Subject: **Bid No. 8689-M6 – Network Upgrades – Durkin Admin Building / WPS**

**ADDENDUM NO. 2**

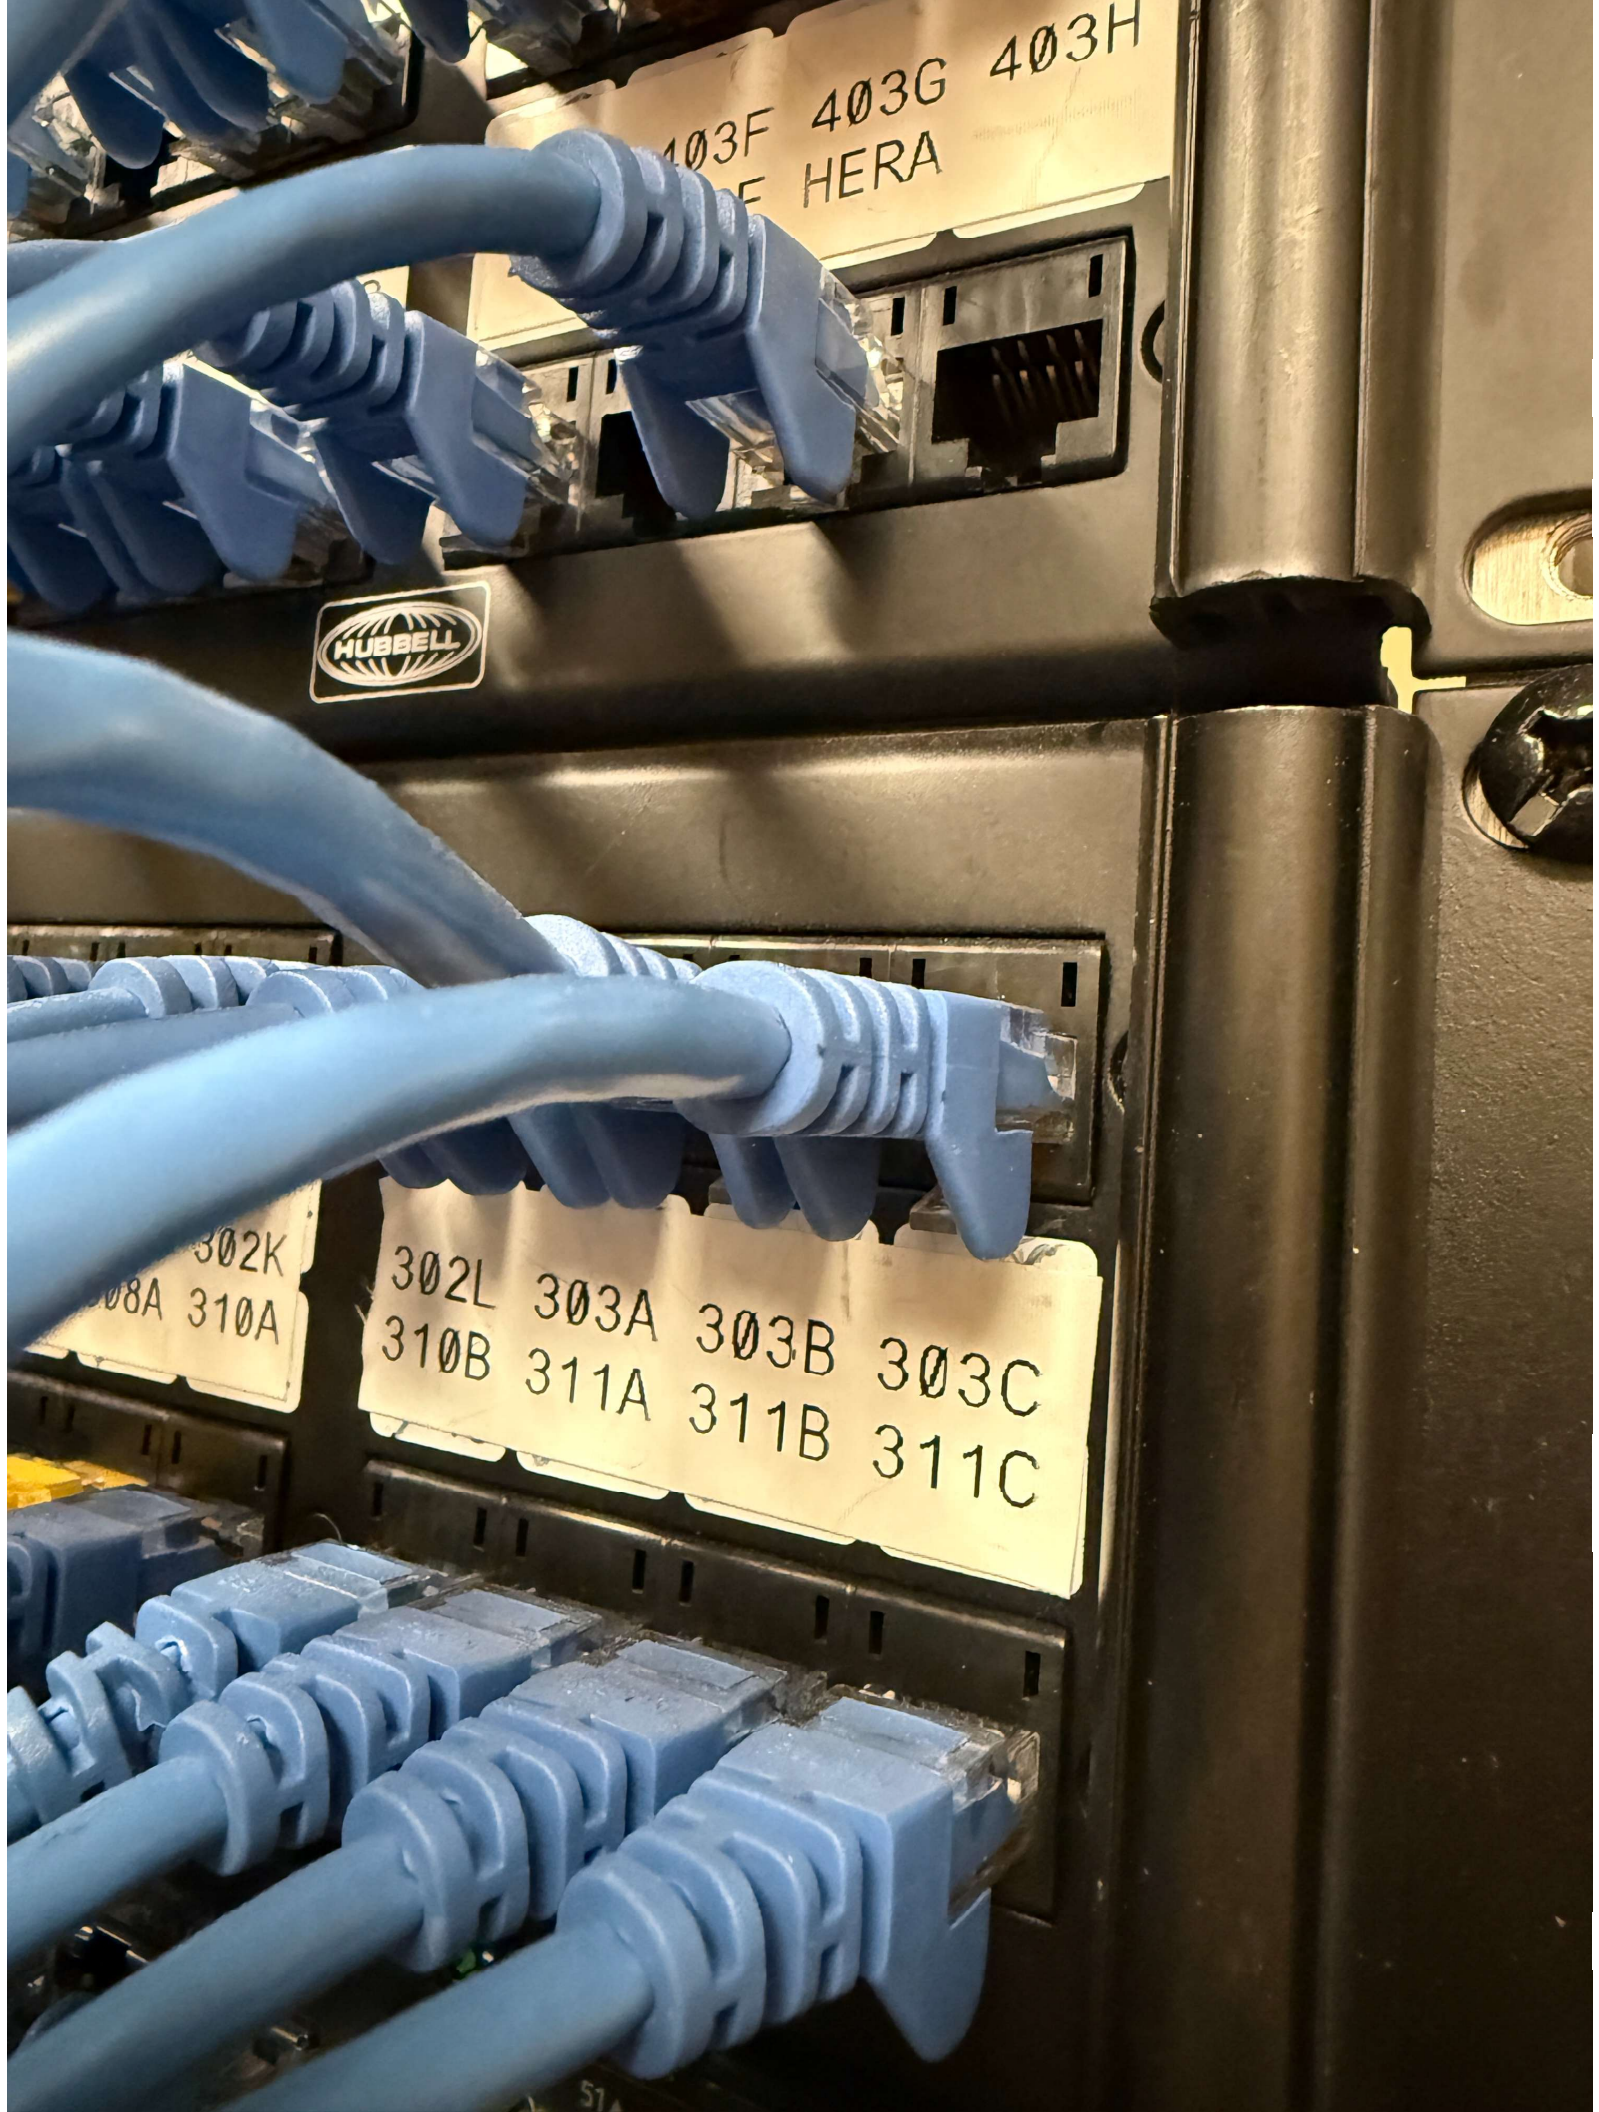
1. How is the vendor going to test existing cables after re-termination? The majority of existing cables are not labeled and have no identifying markings. Determining the device end will be next to impossible.

**Answer: This isn't the case. Most of the panels do in fact have labels on them. See attached pictures.**
2. When the re-termination begins, the building will not have data connectivity. Is there a plan in place to keep the building active during this period (WPS will have removed network hardware prior to work commencing)?
